CRISIS ZONE DX - MODIFICATION

CRISIS ZONE

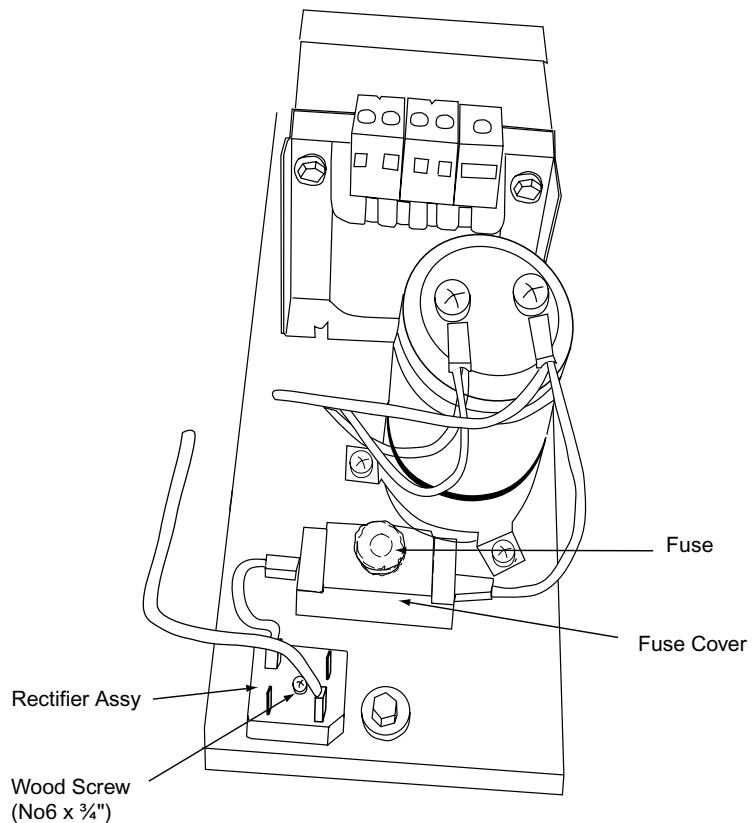
- 2 Fit the new bridge rectifier as shown below using 1 off wood screws No6 x $\frac{3}{4}$ ".

- 4 Disconnect the grey wire, going to the gun, from the fuse holder.

- 5 Connect the wire, with the flat blade, from the rectifier to the grey wire previously removed from the fuse holder.

- 5 Connect the other wire from the rectifier to the fuse holder.

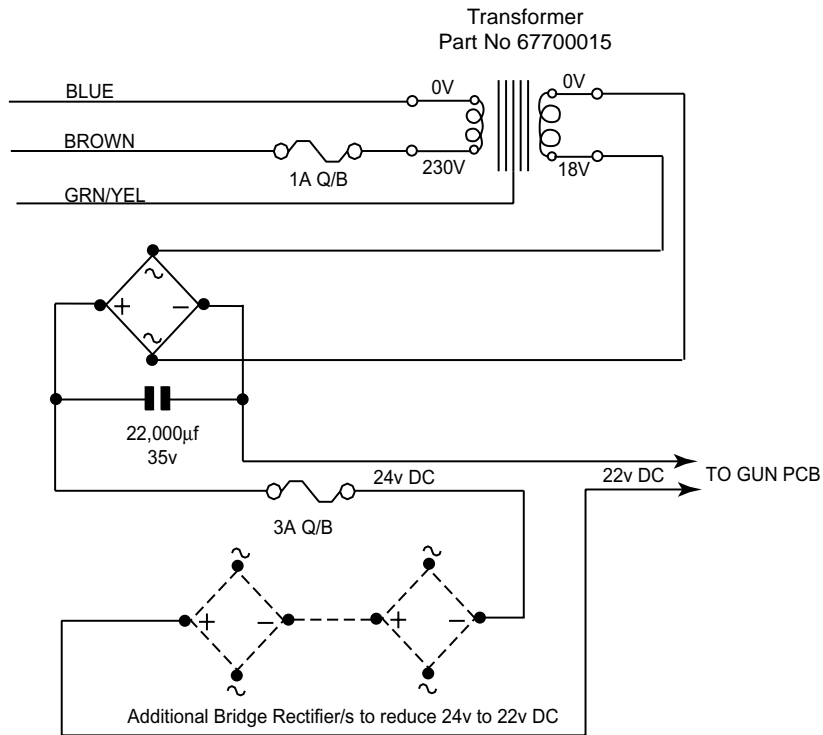
To extend the life of the Gun Motor, it has become necessary to reduce the voltage to the motor from 24v DC (as shown on the schematic), to 22v DC.

This has been accomplished by the addition of 1 or 2 bridge rectifiers placed in the circuit between the 24v DC 3A Fuse and the Gun PCB.

Bridge Rectifier
Part No. 71000040
